**STATE OF NEW HAMPSHIRE**  
**BEFORE THE**  
**NEW HAMPSHIRE SITE EVALUATION COMMITTEE**  
**DOCKET NO. 2015-06**

**SUPPLEMENTAL PRE-FILED DIRECT TESTIMONY OF CARL MARTLAND**  
**ON BEHALF OF**  
**NORTH COUNTRY SCENIC BYWAYS COUNCIL**

**FILED IN OPPOSITION TO THE APPLICATION OF NORTHERN PASS**  
**TRANSMISSION, LLC AND PUBLIC SERVICE COMPANY OF NEW HAMPSHIRE**  
**D/B/A EVERSOURCE ENERGY**  
**FOR A CERTIFICATE OF SITE AND FACILITY TO CONSTRUCT A NEW HIGH**  
**VOLTAGE TRANSMISSION LINE AND RELATED FACILITIES IN NEW HAMPSHIRE**

**MARCH 24, 2017**

## View of proposed transmission lines from NH 145, Clarksville (Moose Path Trail)

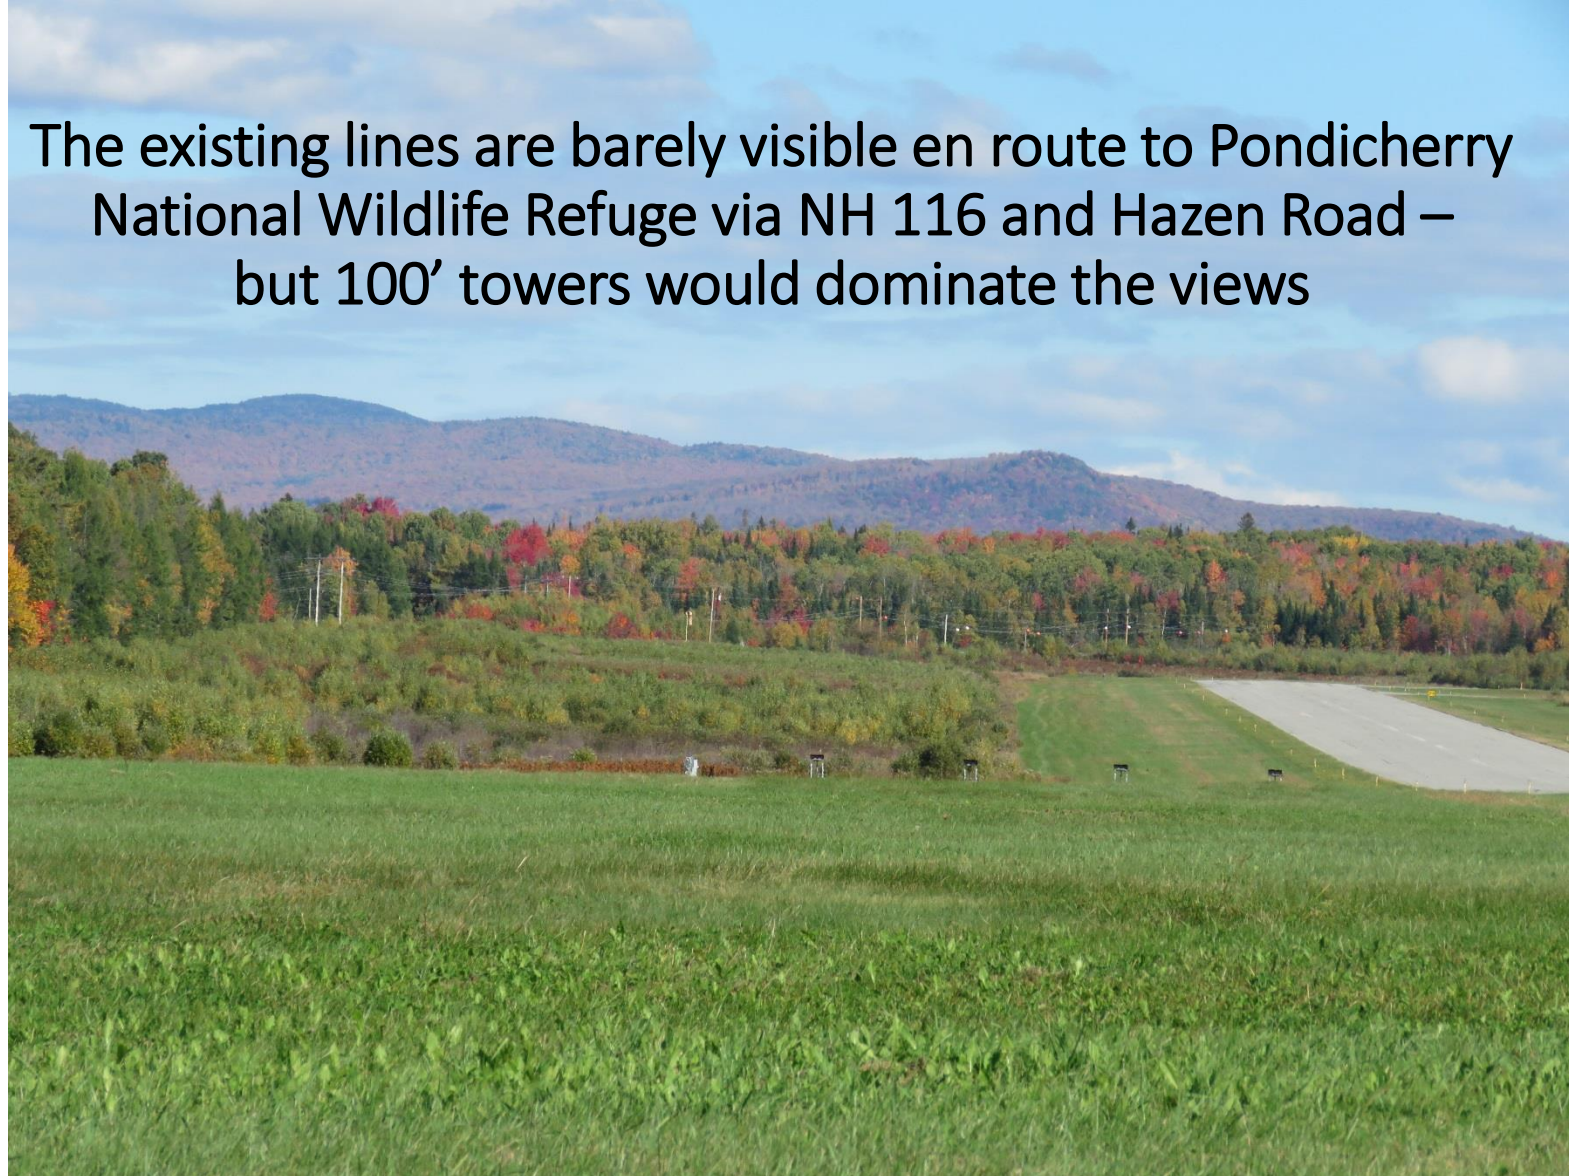
View of several towers crossing a ridge at a distance of less than a half mile would be deemed “adverse” and maybe “unreasonably adverse” using methodology in draft EIS for NPT (compare KOP WD-3)

LA-2 View from summit to row of towers in valley: Moderate (23)  
(Weeks State Park - View toward Jefferson: 34 structures, 5981 feet)

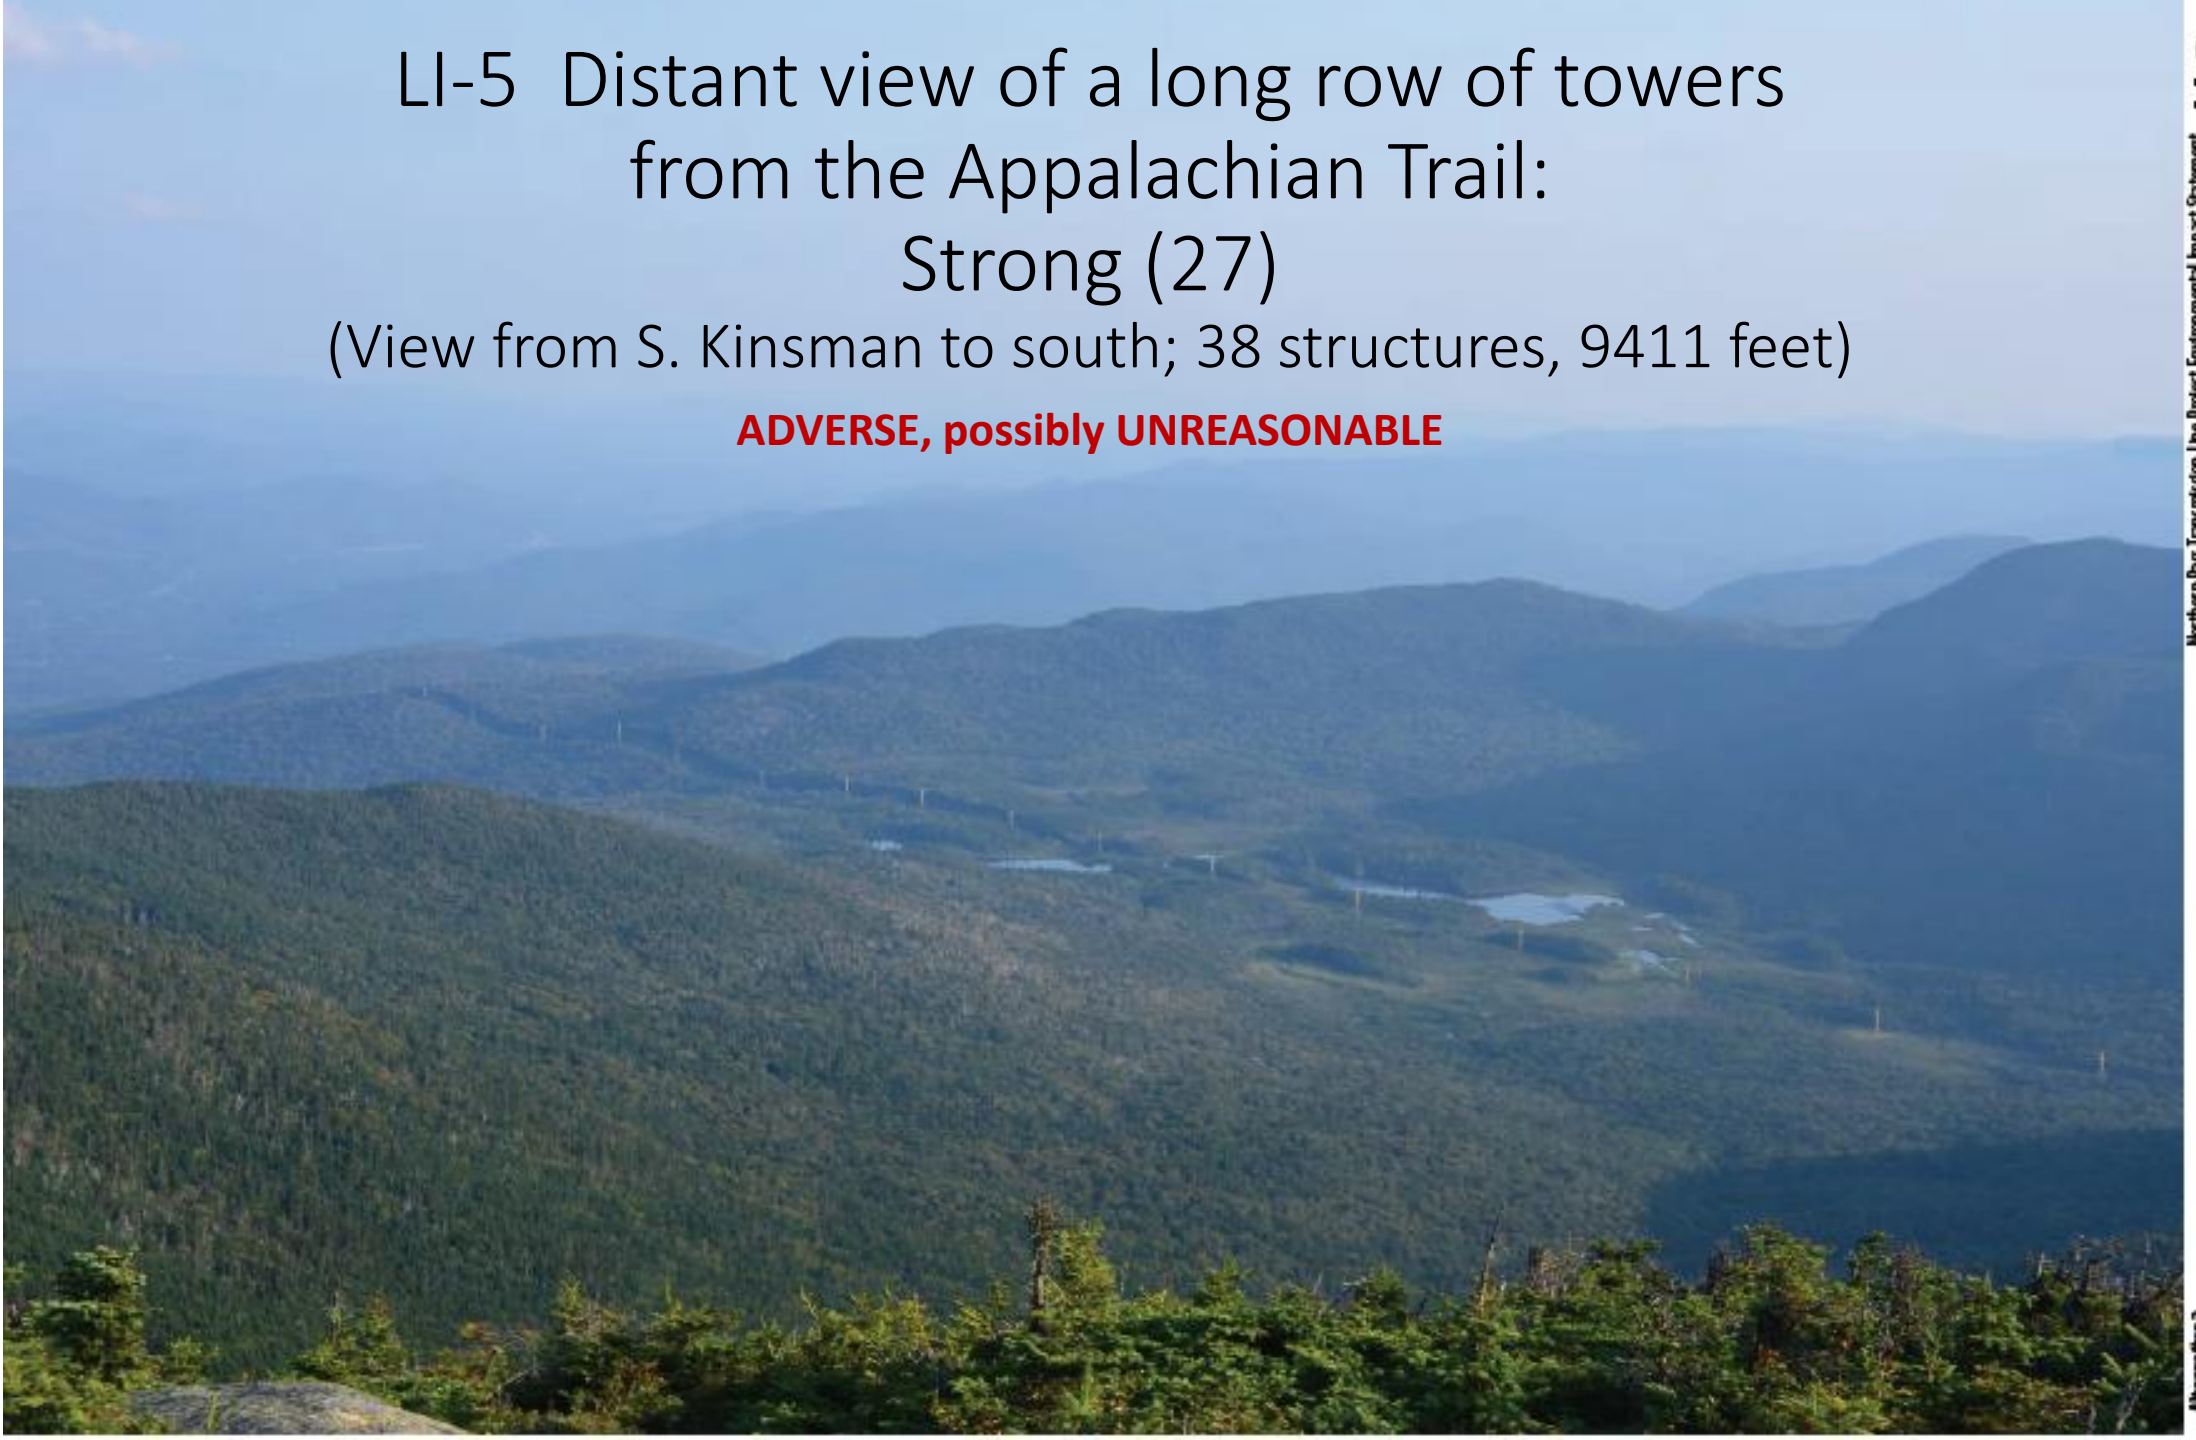
**ADVERSE**

# CL-1: Transition Station and towers: Strong (29)

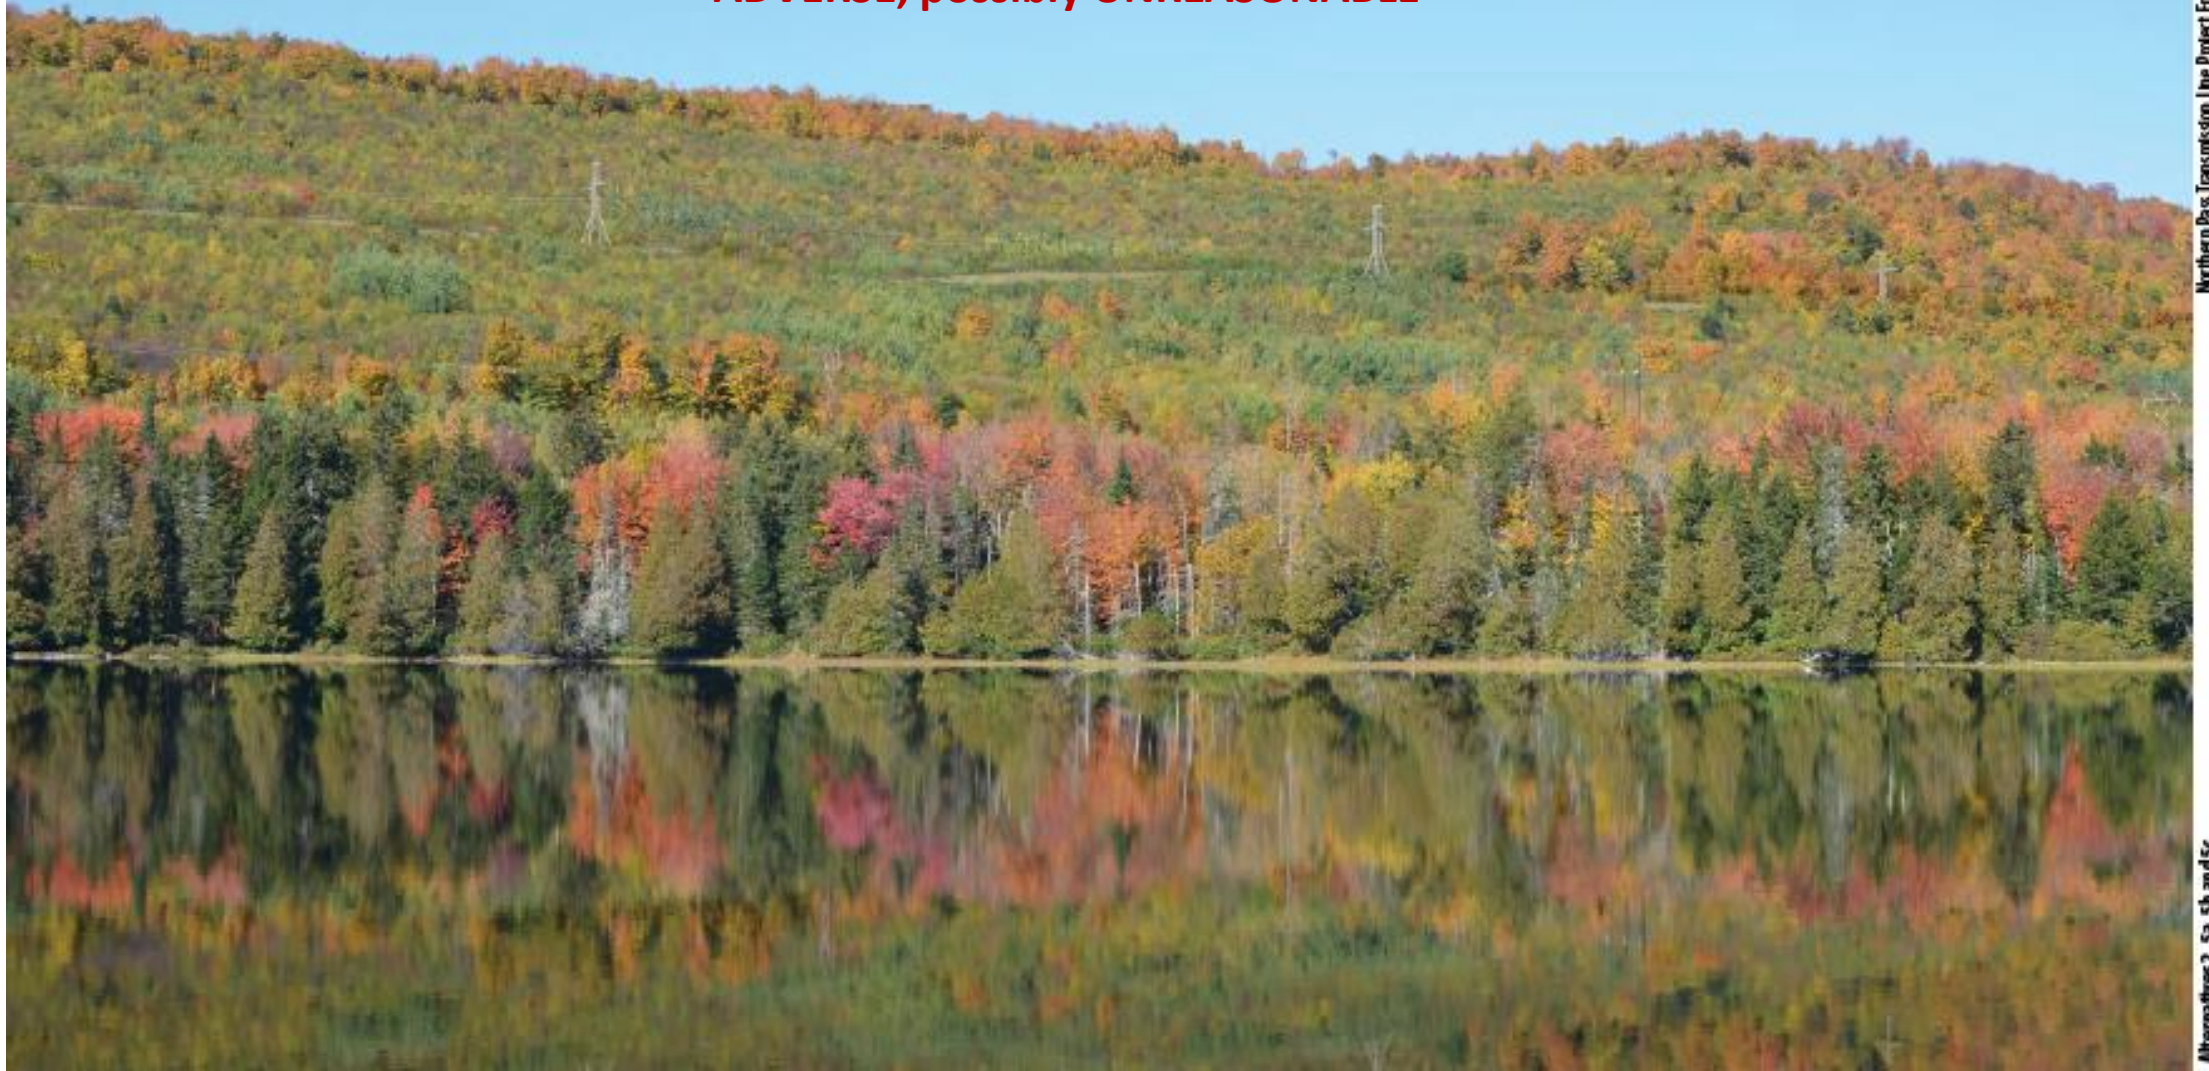
**ADVERSE, possibly UNREASONABLE**

EA-3 Looking directly down rows of towers  
and monopoles: Severe (36)  
(Easton, original plan: 25 structures, 126 feet)

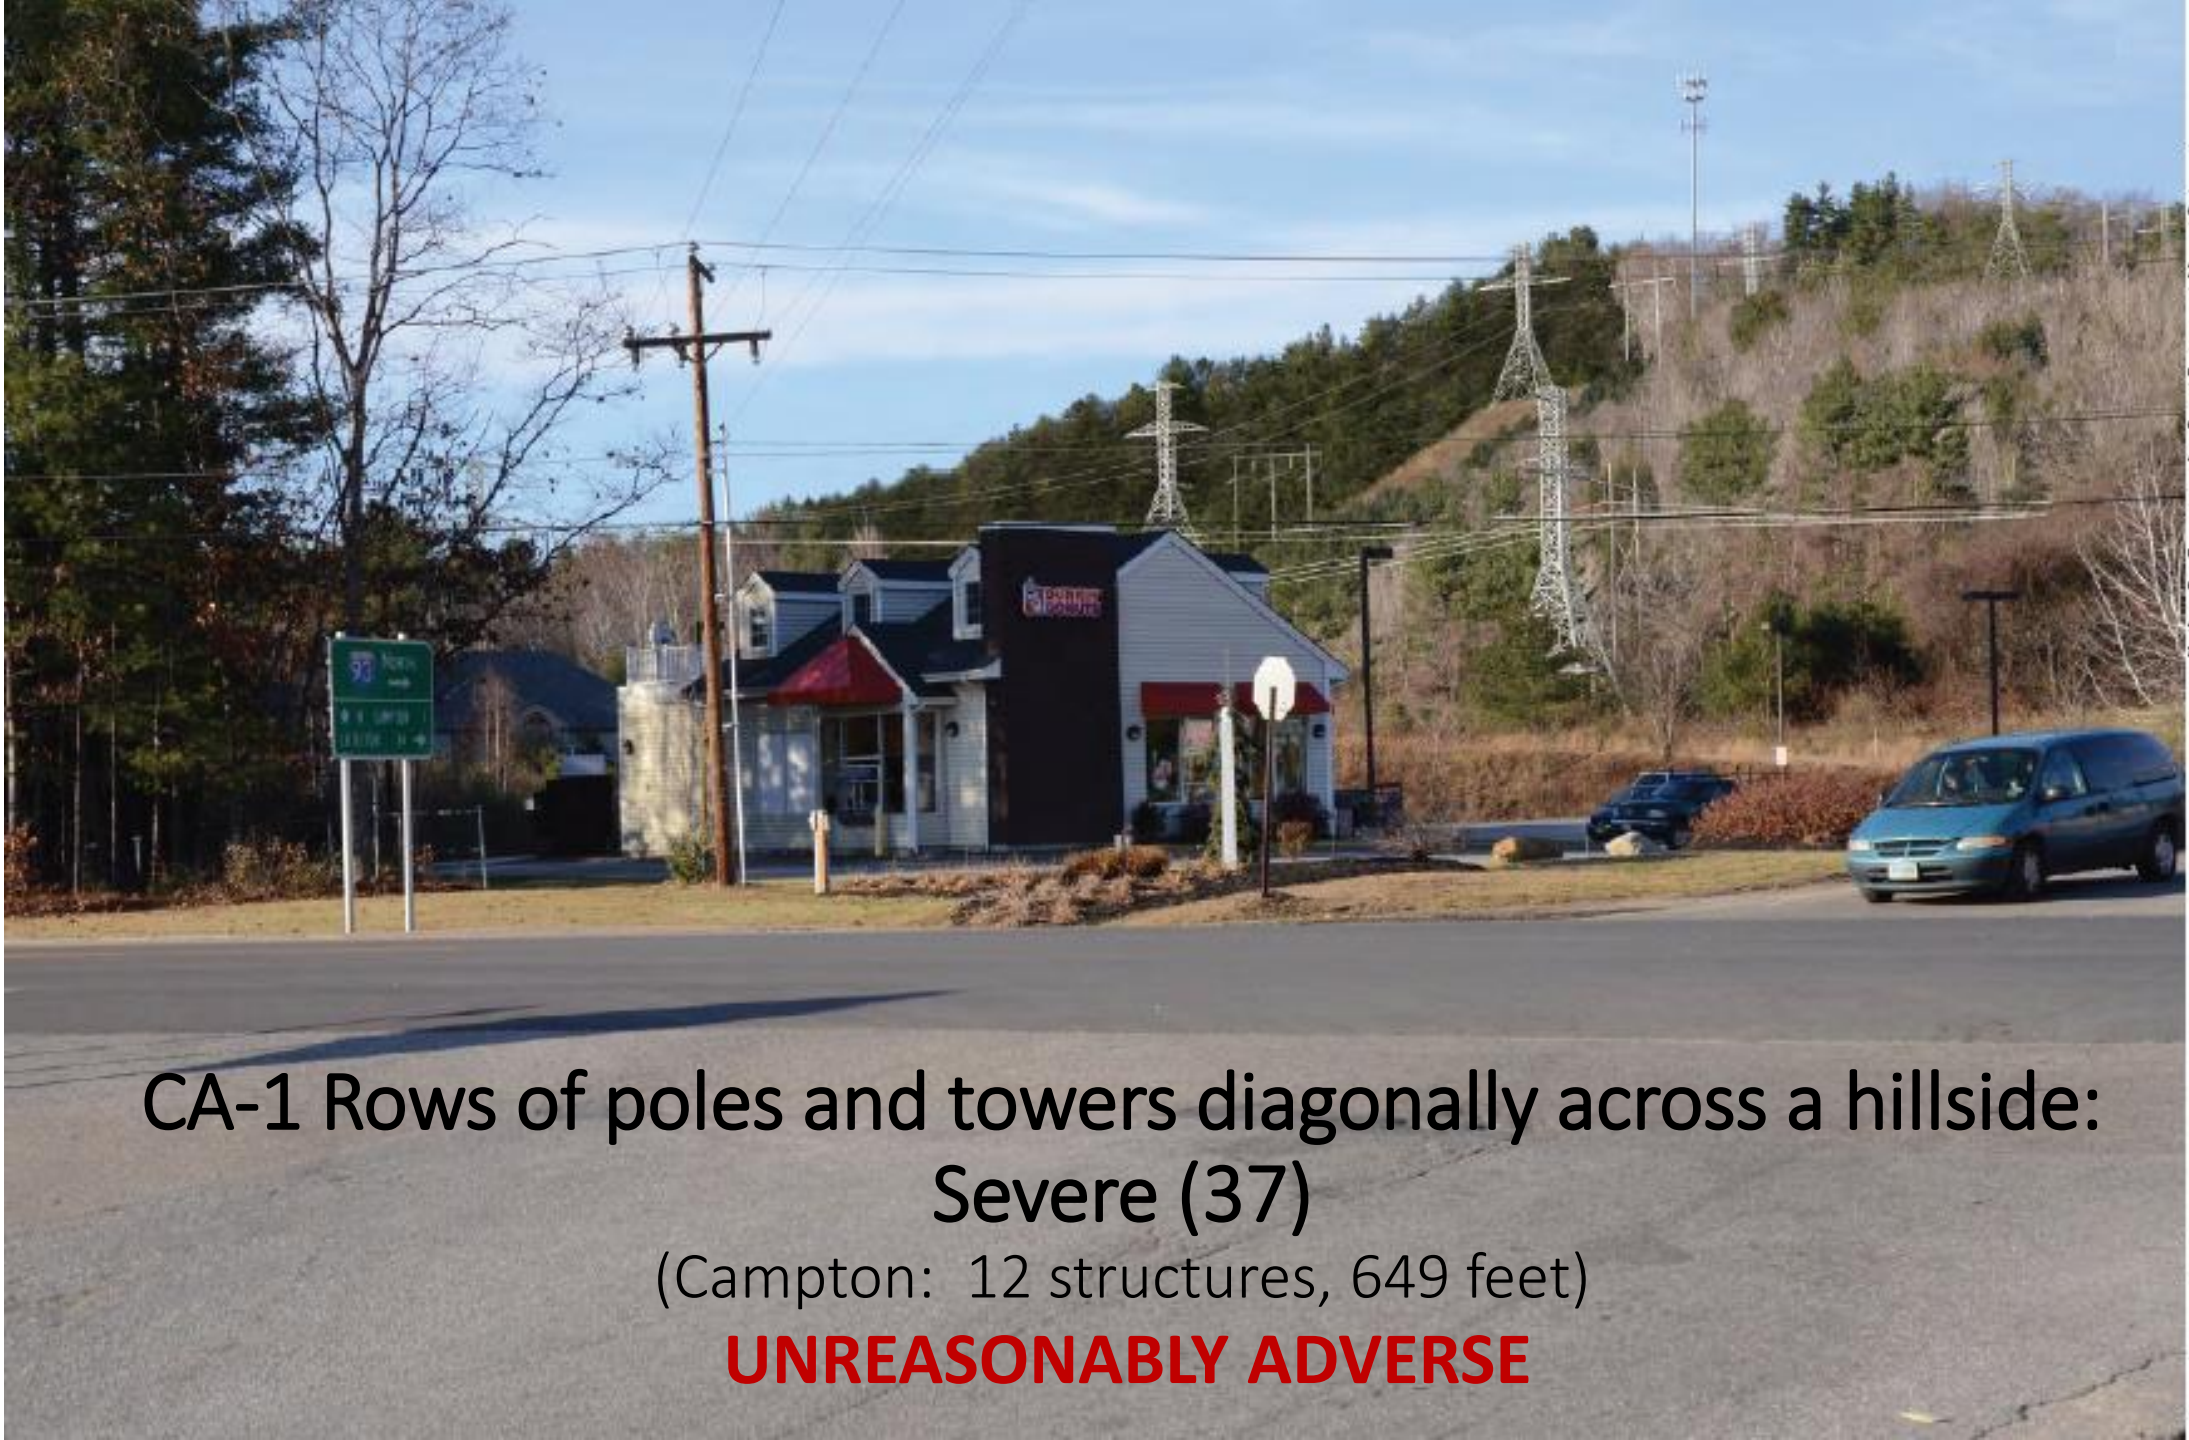
**UNREASONABLY  
ADVERSE**
